MEMORANDUM

Subject: Response to VHB Comments dated March 4, 2021

Date: March 19, 2021

On January 14, 2021 our office published a revised “Traffic/Parking Evaluation” memorandum for the proposed student housing parking lot at 19-21 Main Street in Durham, New Hampshire. We are now in receipt of several comments from VHB, Inc., the Town’s peer review consultant. The purpose of this memorandum is to summarize our responses to those comments.

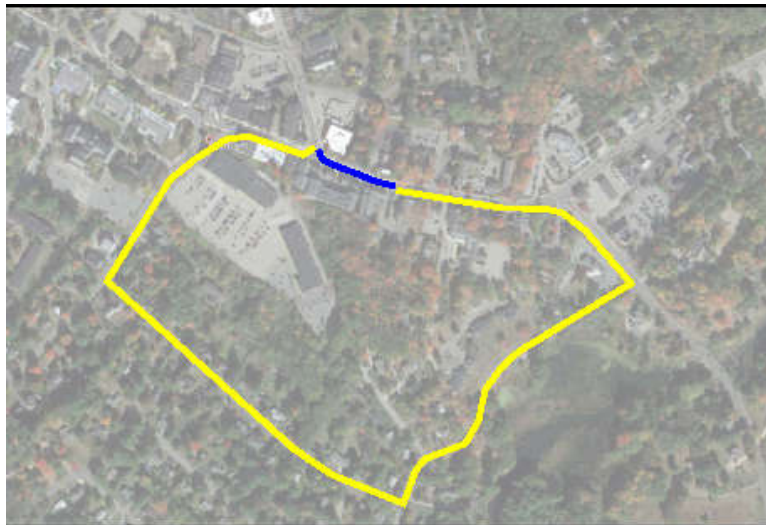
VHB Comment 10: *“The applicant should conduct an assessment to determine which alternate routes motorists may consider (e.g., based on proximity, travel time, roadway characteristics, legislative class, etc.) should the left turns exiting from the site driveway be projected to experience operational deficiencies.”*

SGP & Co., Inc. Response: The analysis of traffic operations at the subject intersection suggests that drivers exiting left will not experience inordinate delays (2031 PM average control delay = 29 seconds) leaving the site driveway, and then following the “blue” route 0.08 miles on Main Street to reach Madbury Road. The diagram below shows that exiting right on the “yellow” route to reach Madbury Road will involve a travel distance of approximately 1.03 miles that includes one traffic signal and several stop signs. In our view, this is not an attractive alternative route and most exiting drivers will prefer the shorter route to Madbury Road.
